W3F1-2003-0074

November 13, 2003

SUBJECT: License Amendment Request NPF-38-249
Extended Power Uprate
Waterford Steam Electric Station, Unit 3
Docket No. 50-382
License No. NPF-38

FIGURE 3.1-1

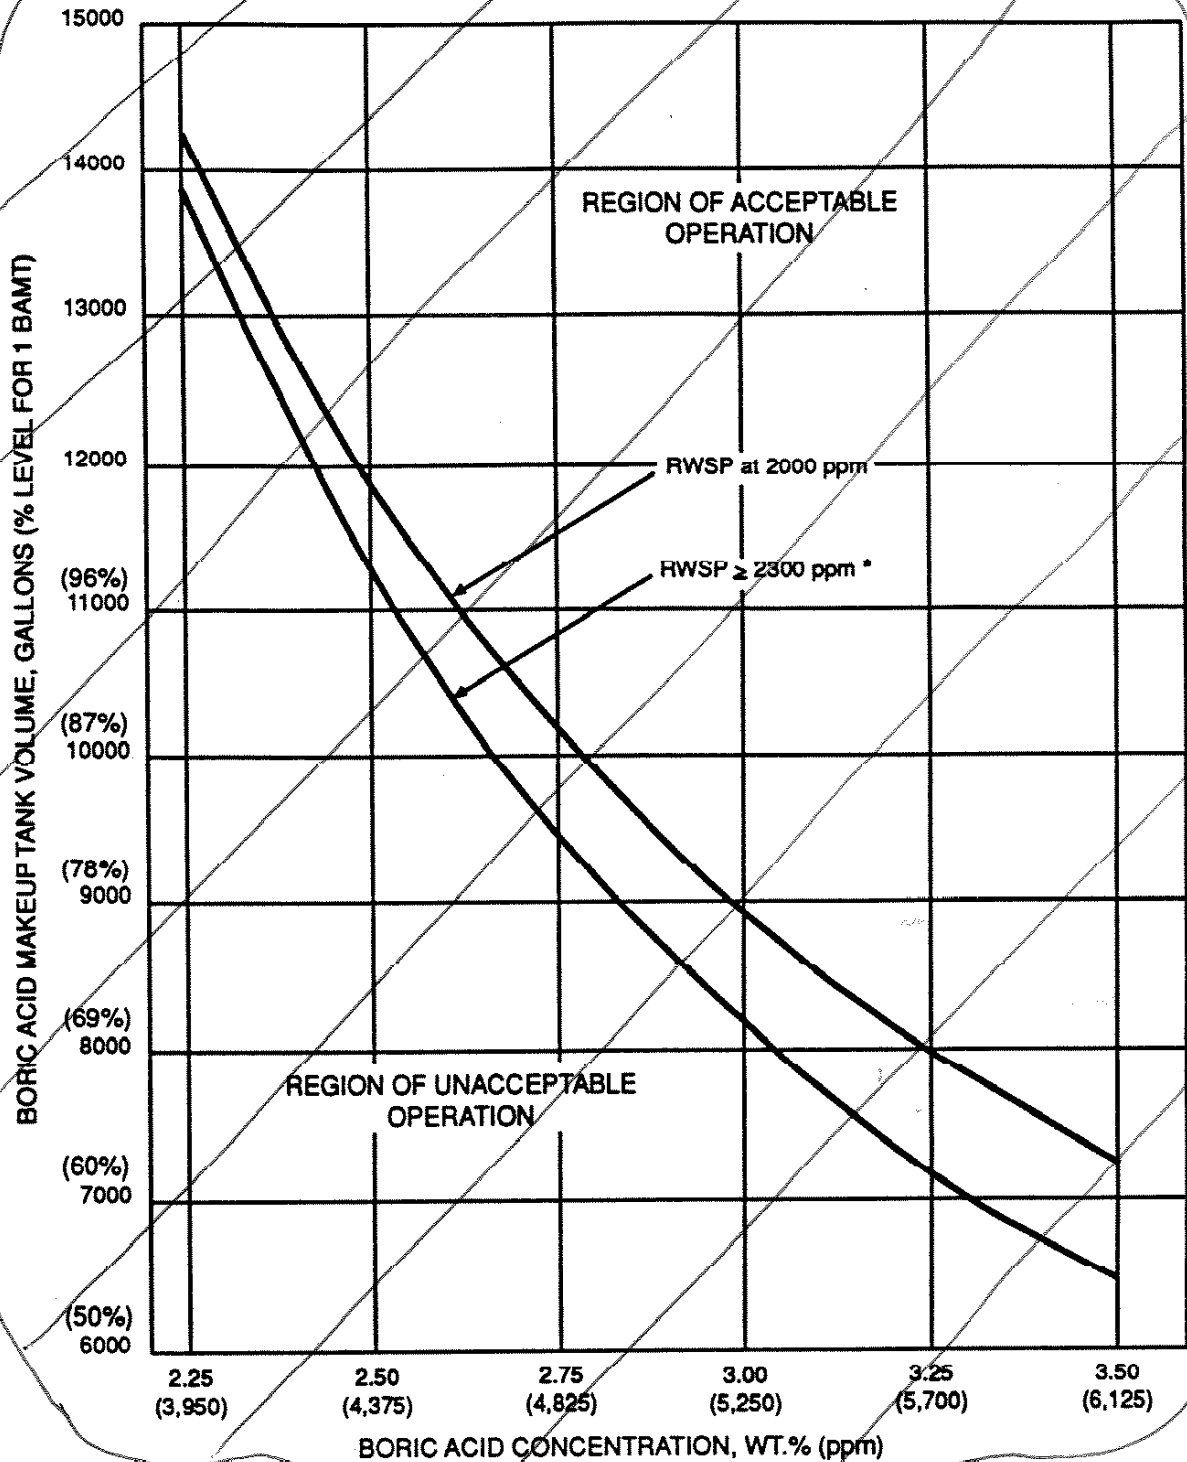
Figure 3.1-1 in 3.1.2.8a.2 is changed to new Figure 3.1-2. This is an EPU related change.

Figure 3.1-1 is replaced with a new figure to reflect the revised minimum boric acid concentration of 4900 ppm and an increase in Boric Acid Makeup Tank (BAMT) minimum volume required when relying on one BAMT. New Figure 3.1-2 is added to reflect the revised BAMT boron concentration and volume requirements when relying on two BAMTs. This is an EPU related change.

The page number for Figure 3.1-1 is changed from 3/4 1-13 to 3/4 1-14.

Replace with
Insert Figure
3.1-1

The increase in the minimum required boron concentration (to 4900 ppm) and minimum BMT volume ensures that shutdown margin requirements will be met during natural circulation cooldown to shutdown cooling entry conditions. This minimum concentration, revised Figure 3.1-1, and new Figure 3.1-2 resulted from the evaluation of the Chemical and Volume Control System (CVCS) described in PUR Section 2.1.11.
